## **BACKGROUND**

## **PROPOSAL**

The applicant proposes to demolish the existing accessory structure and construct a new two-car garage in the same location. The applicant further proposes to remove the asphalt drive and install a new paver drive to access the rear of the property.

**STAFF RECOMMENDATION**

Figure 2: 1927 Sanborn Map showing the subject property and garage in the northwest corner of the lot.

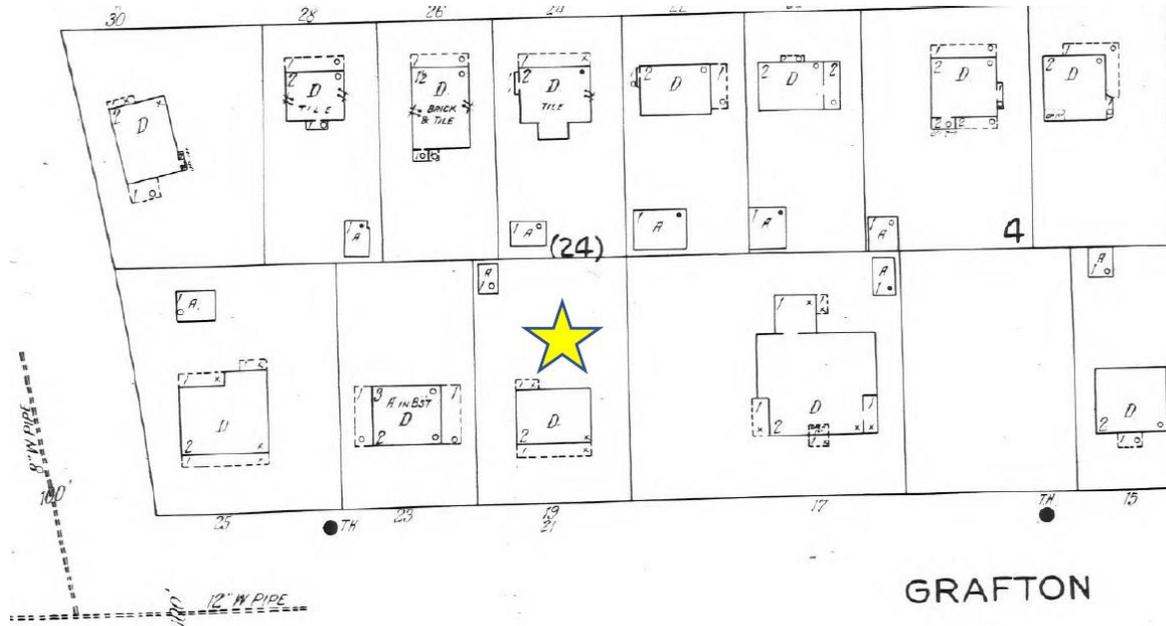
The existing accessory structure is a one-bay structure covered in corrugated metal siding and roofing. Staff is reluctant to call this structure a garage, as the driveway does not extend all the way back to this location. The Sanborn map (see below) shows a structure in this location and the 'A' indicates that it is an auto garage. Staff is unsure if the existing structure is the one identified on the map as the exterior materials are not consistent with a garage of this era. Staff finds that the accessory structure has significantly deteriorated and is likely beyond repair. Specifically, the slab has a significant crack and the corrugated metal siding shows rust and corrosion. Under the *Design Guidelines* detached accessory structures are to be reviewed under lenient scrutiny. Removing this structure would not significantly impact the scale and massing of the site or have a significant impact on the surrounding district, and under very lenient interpretation of preservation rules, the demolition should be supported. Staff recommends approval of the demolition of this structure.

**FRONT ELEVATION**

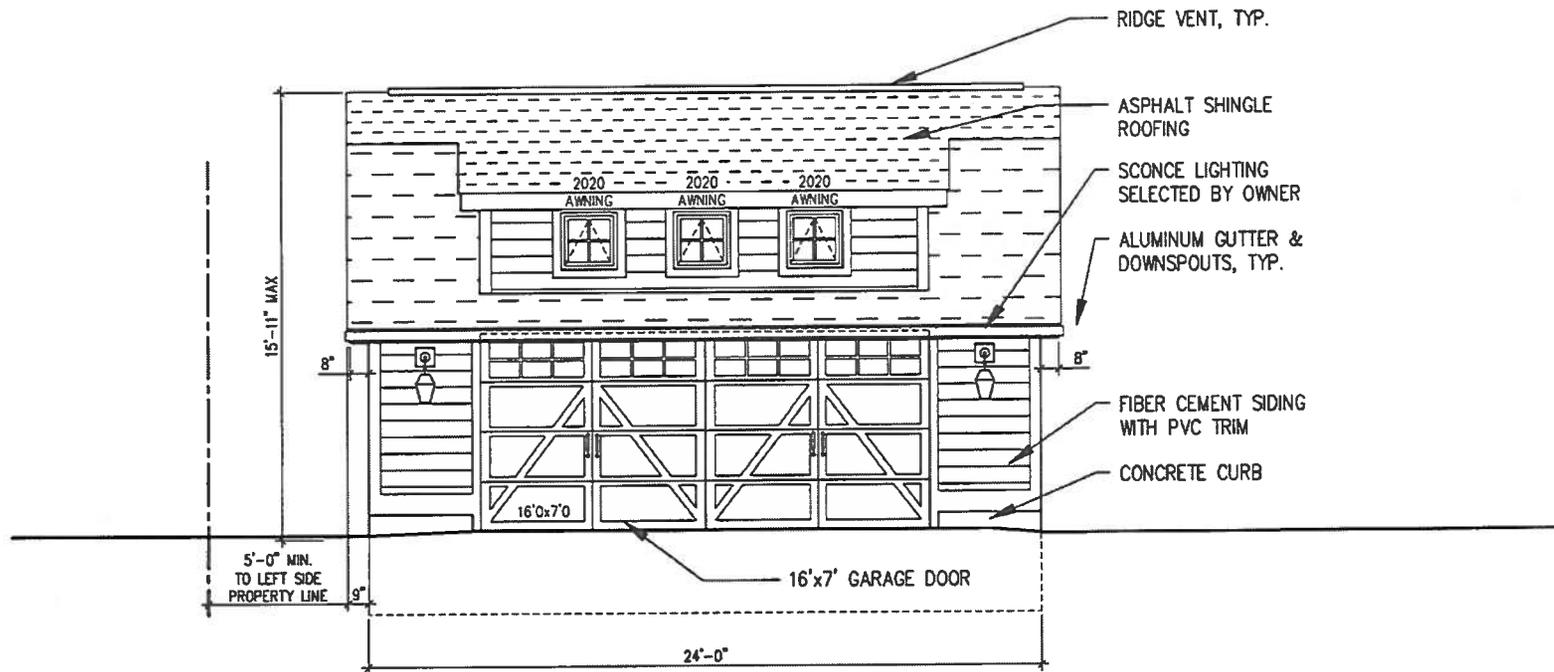
In place of the existing structure the applicant proposes to construct a new two-car garage on a concrete slab that will measure 24' × 24' (twenty-four feet by twenty-four feet). The design submitted has a side gambrel roof with a ridge height of 15' 11" (fifteen feet, eleven inches). The proposed garage will be fiber cement clapboard siding with PVC trim and an architectural shingle roof. The design and material proposed for the new garage will match the approved, rear building addition. There will be three four-lite, wood clad awning windows above the garage doors which will also match the approved windows in the approved rear addition. The garage doors will be wood carriage-style garage doors with lites in the uppermost panel. On the east (right) elevation, there is a wood half-lite main door and a six-over-one sash window, matching the windows approved in the rear addition.

Under the *Design Guidelines* for the Chevy Chase Village Historic District, detached accessory structures are to be reviewed under lenient scrutiny, but should be compatible with the historic building. Staff finds that the gambrel roof, materials, and windows make the proposed accessory structure compatible with the historic house and its approved addition. The remainder of the analysis focuses on the issue of massing and impact on the surrounding streetscape. Because this building is located at the rear of the lot at the minimum setback allowed by code, the proposed garage will have minimal visibility from the public right-of-way. Additionally, the rise from Grafton St. to the house will make the house less visible from the public right-of-way. Staff finds that the proposed garage is appropriate under the lenient scrutiny required and 24A-8(b)(2) and recommends approval.

- 5) Garage. The Prior Proposal involved a higher gambrel 22x28 2-story garage. **The Revised Proposal scales the garage back includes a smaller 24x24 one story garage with second level non-walkable storage space. The garage complies with Chevy Chase Village code and is below 16 feet high.**
